June 24, 2024

To: Plan Holders for Improvements to the
KIRKSVILLE REGIONAL AIRPORT
KIRKSVILLE, MISSOURI
MODOT PROJECT NO. 24-028A-1

**ADDENDUM NO. 5
TO
CONTRACT DOCUMENTS, SPECIFICATIONS AND PLANS
FOR IMPROVEMENTS TO THE
KIRKSVILLE REGIONAL AIRPORT
KIRKSVILLE, MISSOURI
MODOT PROJECT NO. 24-028A-1**

A1 HIGH ROOF HIGH EAVE ROOF DETAIL
A-313 1 1/2" = 1'-0"

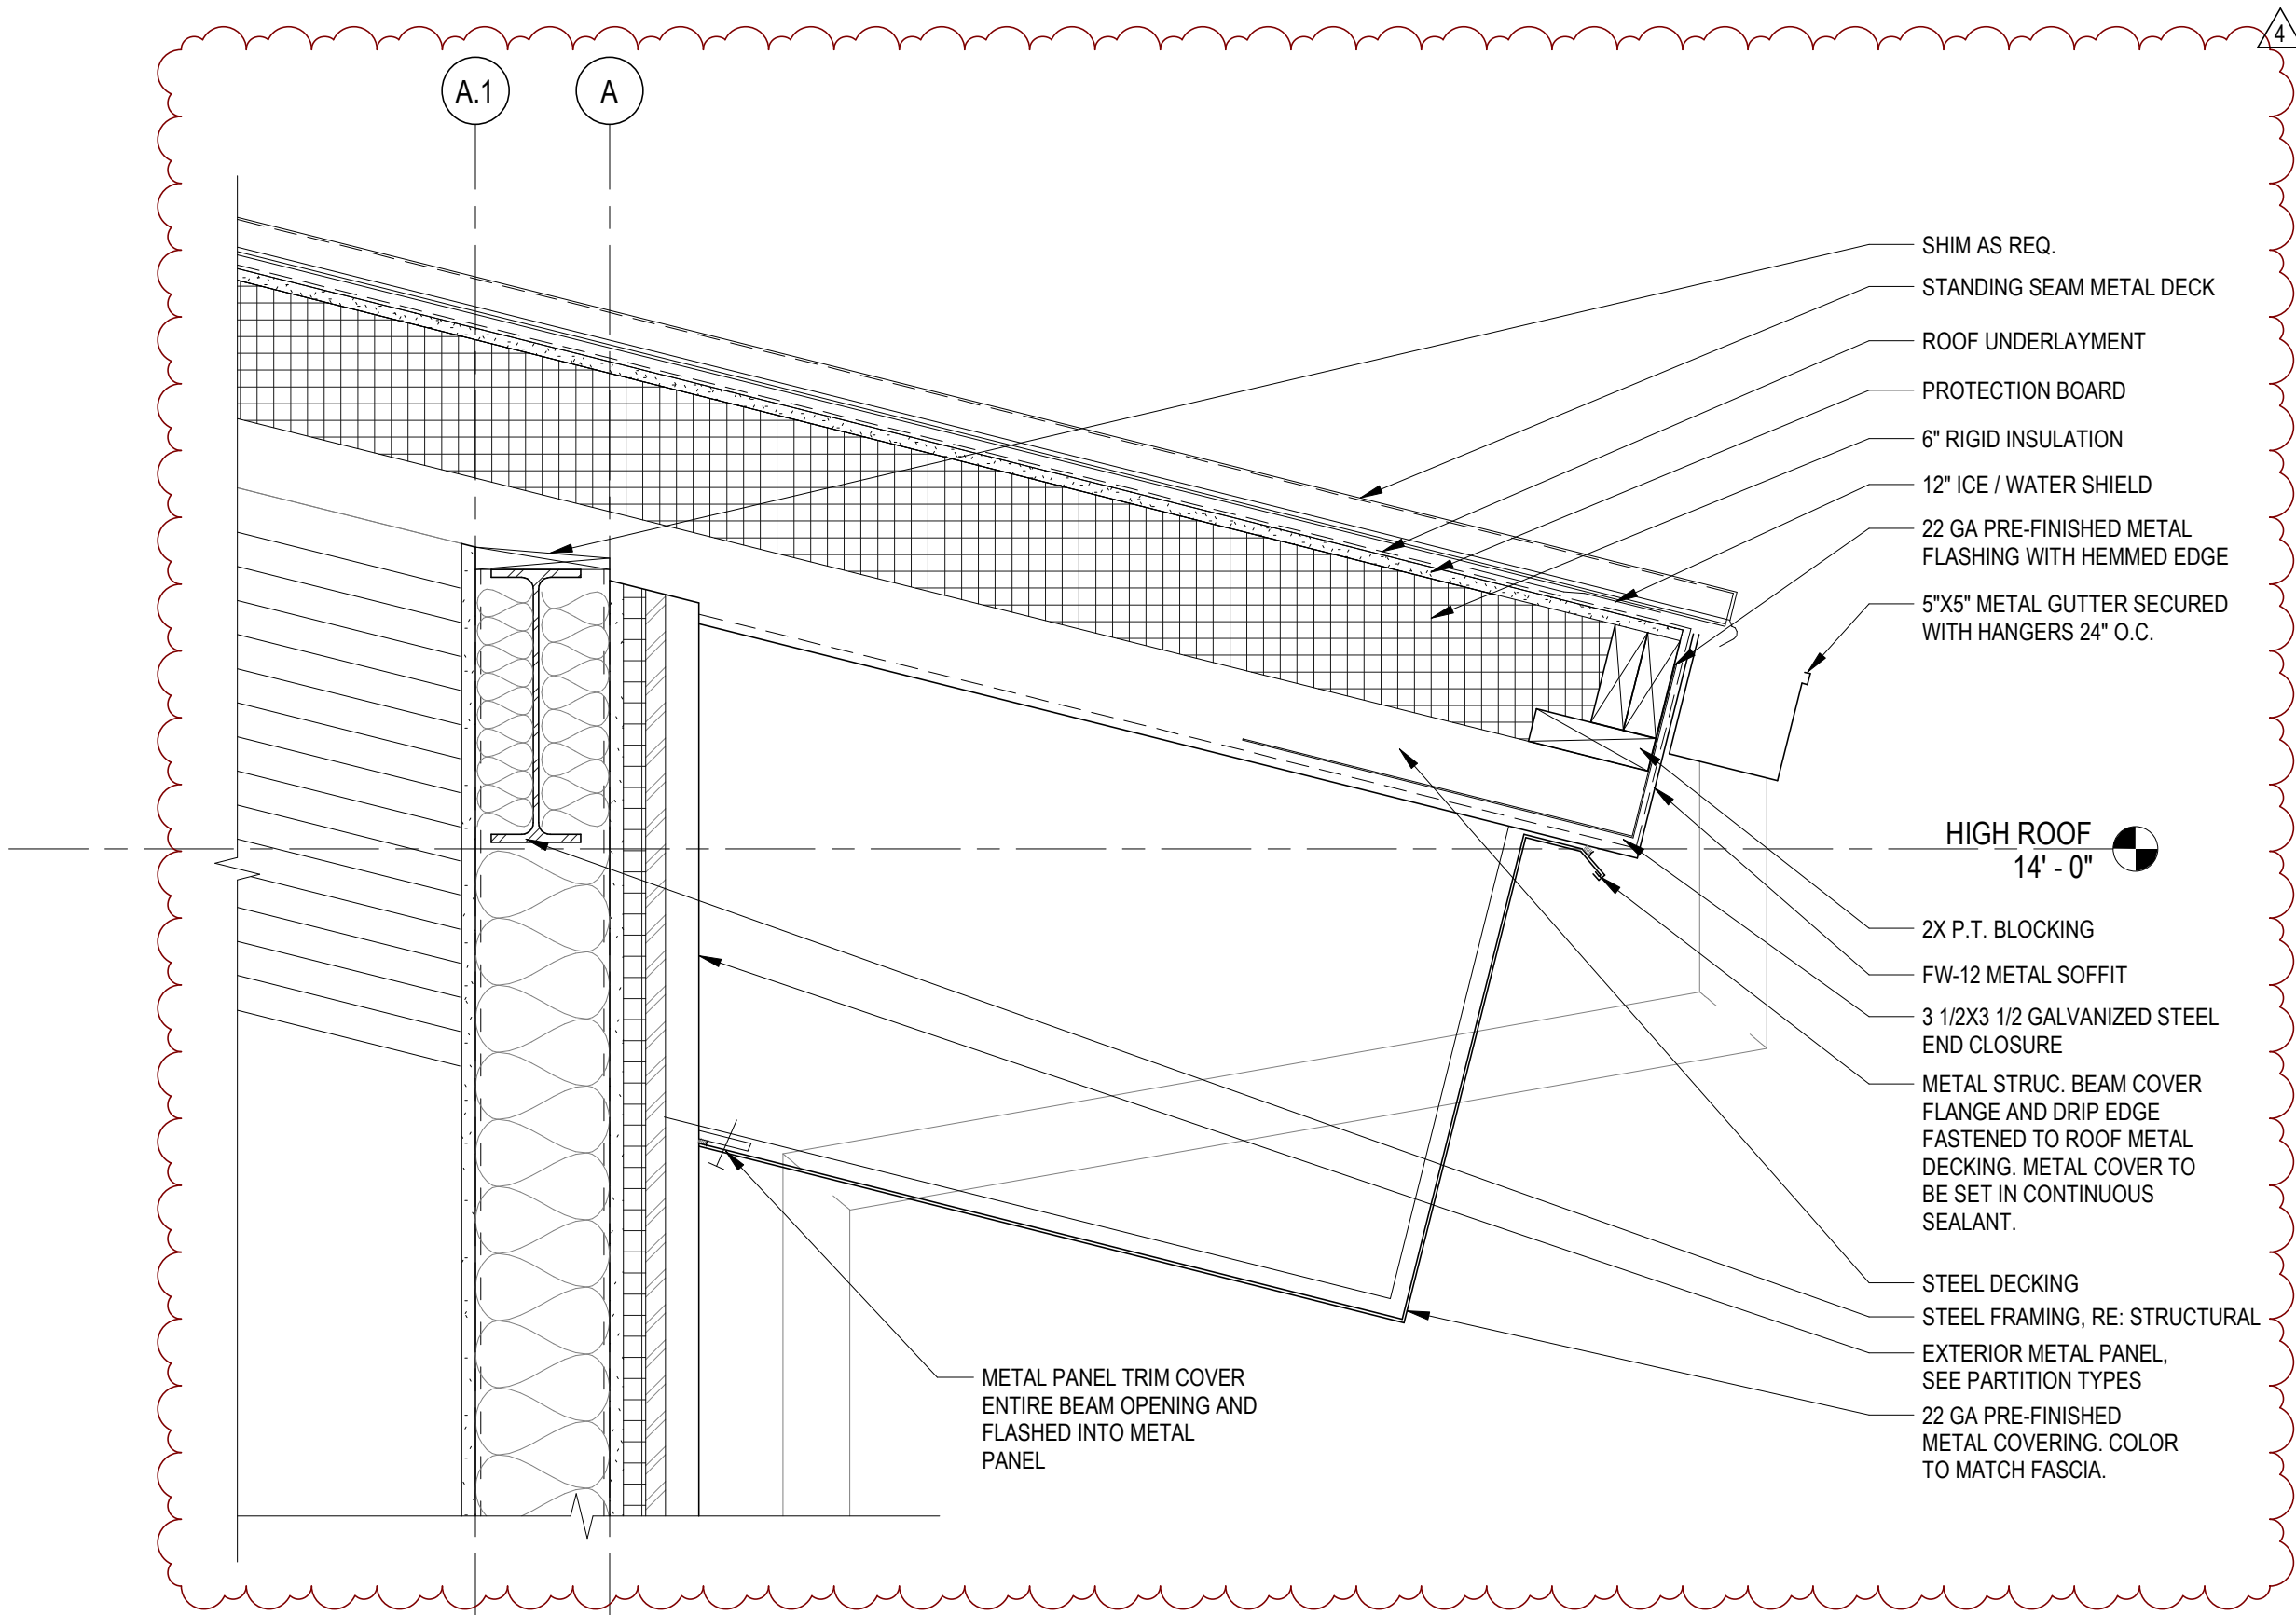
Sheet No.: A-521
Title: ROOF DETAILS
Revision: Ticket Counter details have been revised.
Justification: For clarity.

E-102

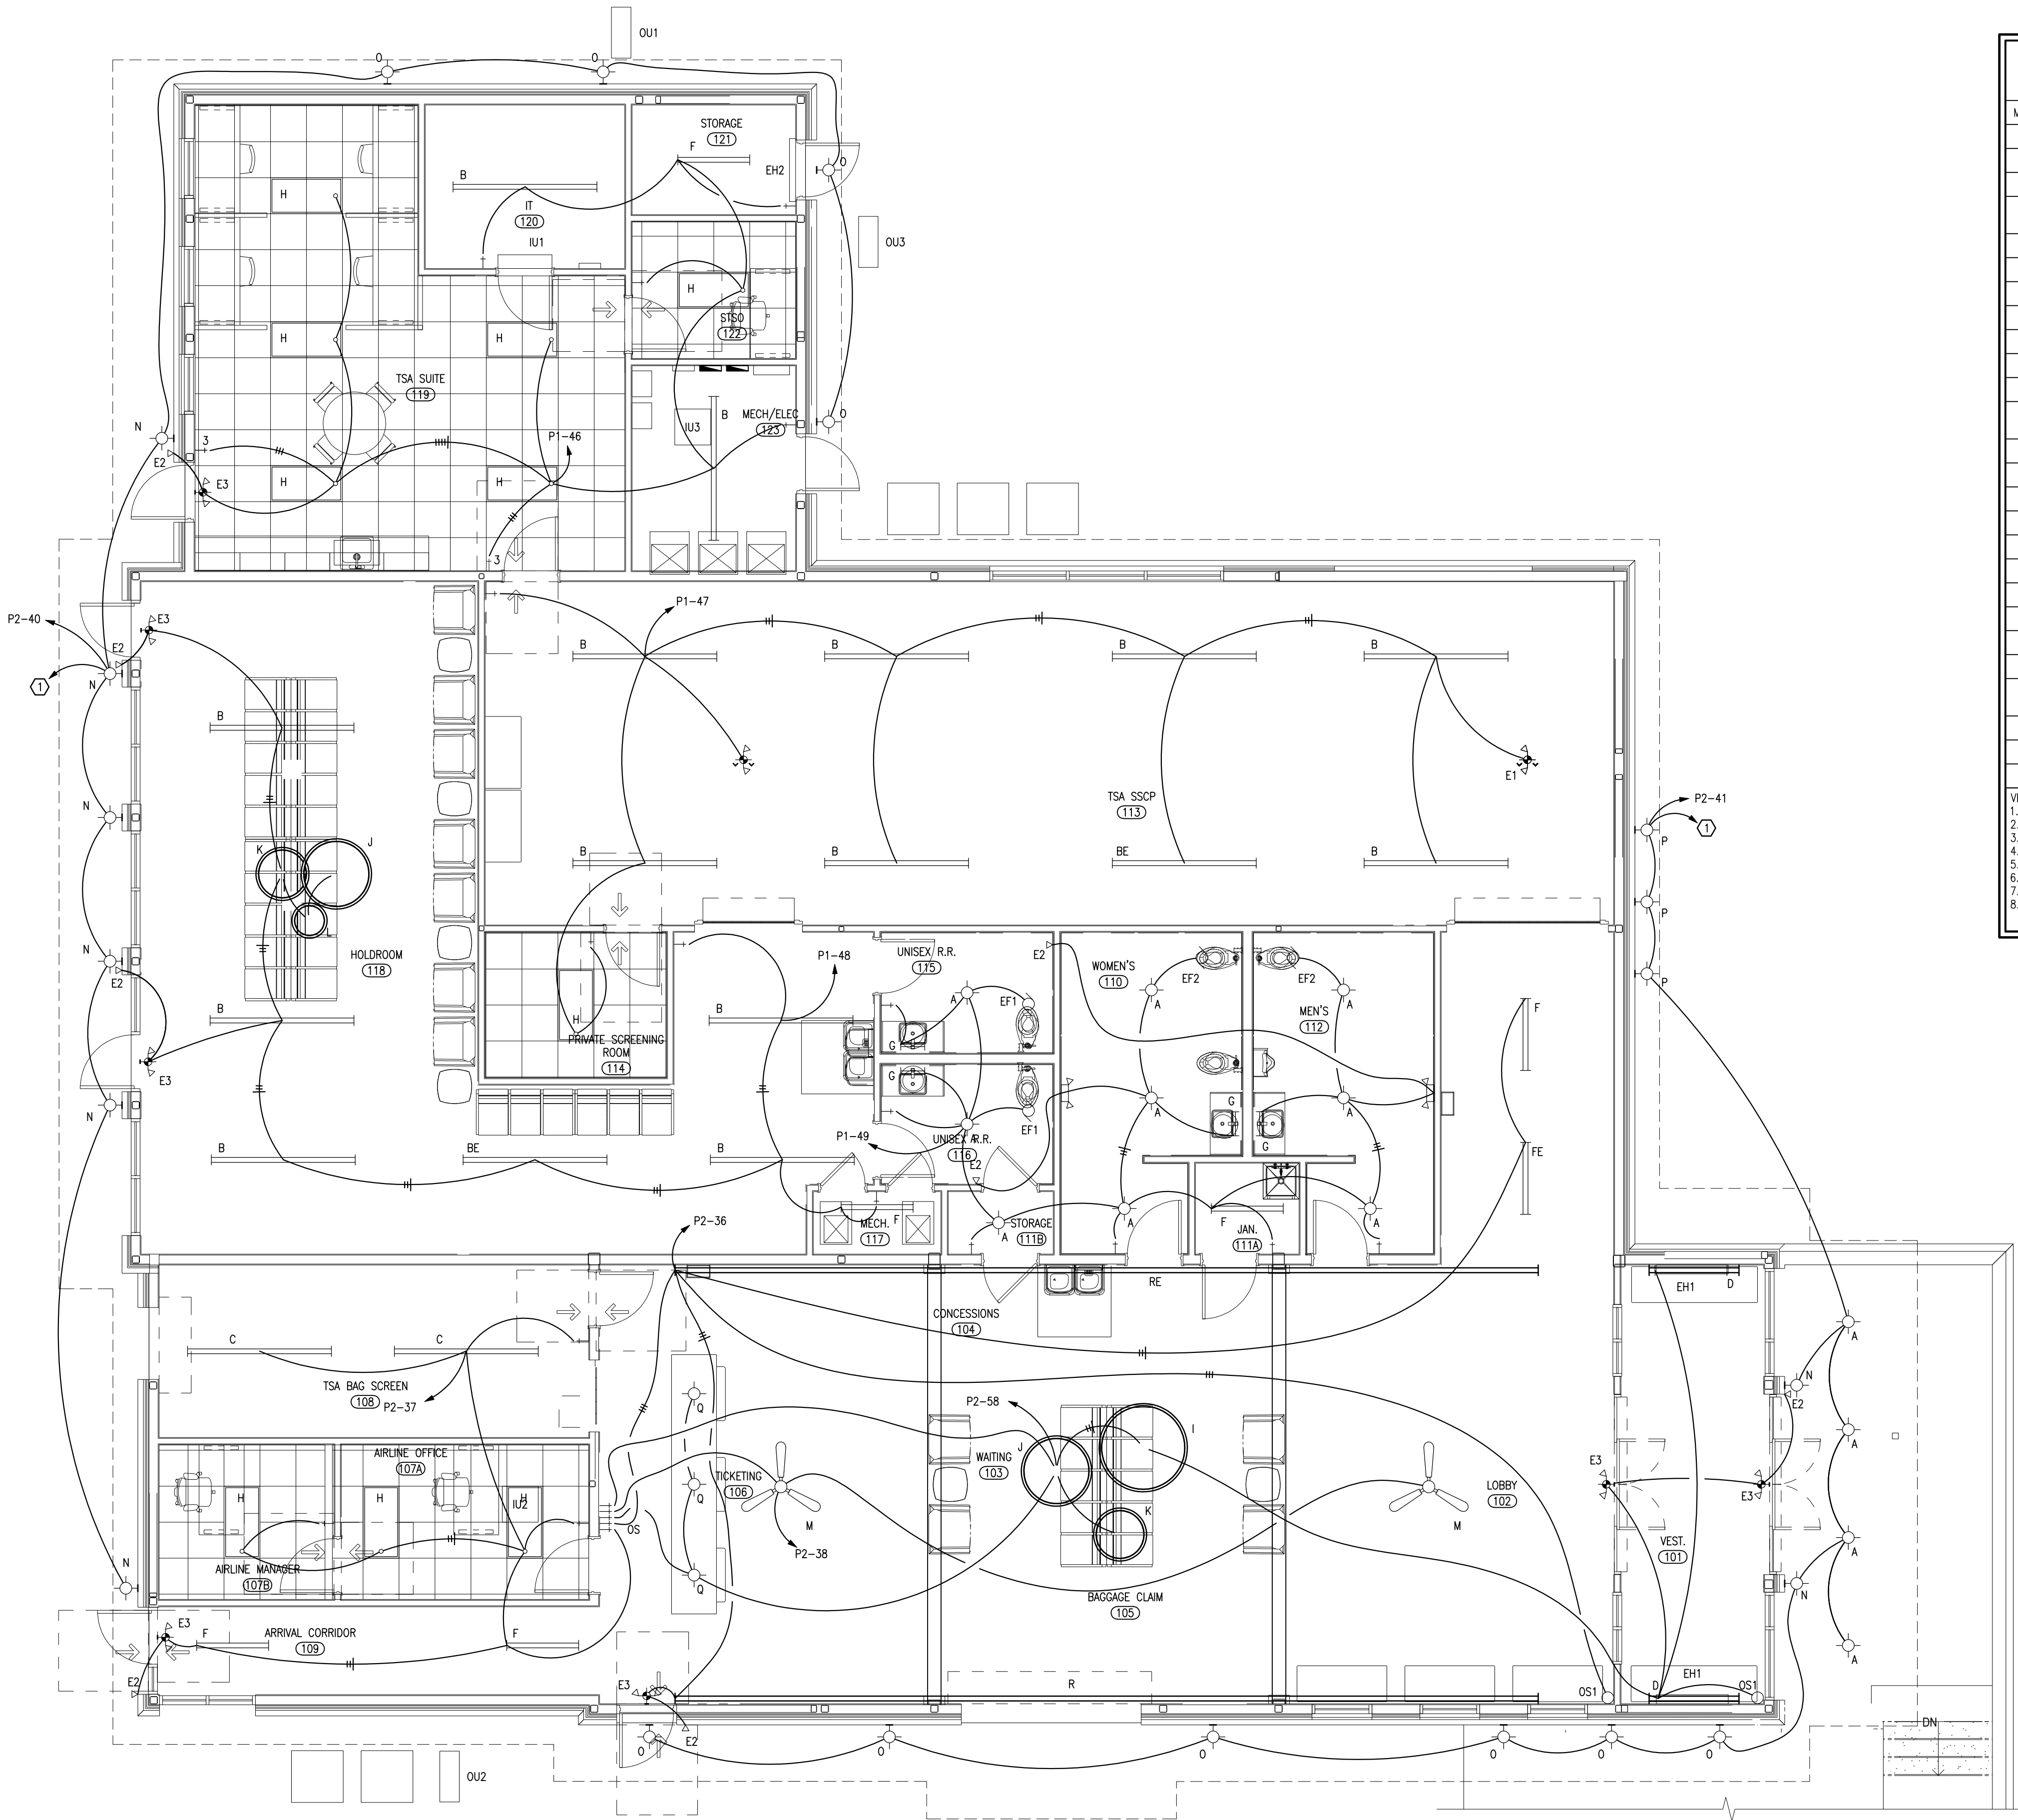
Sheet No.: E-102
Title: LIGHTING PLAN
Revision: Lighting Schedule
Justification: Updated lighting selections.
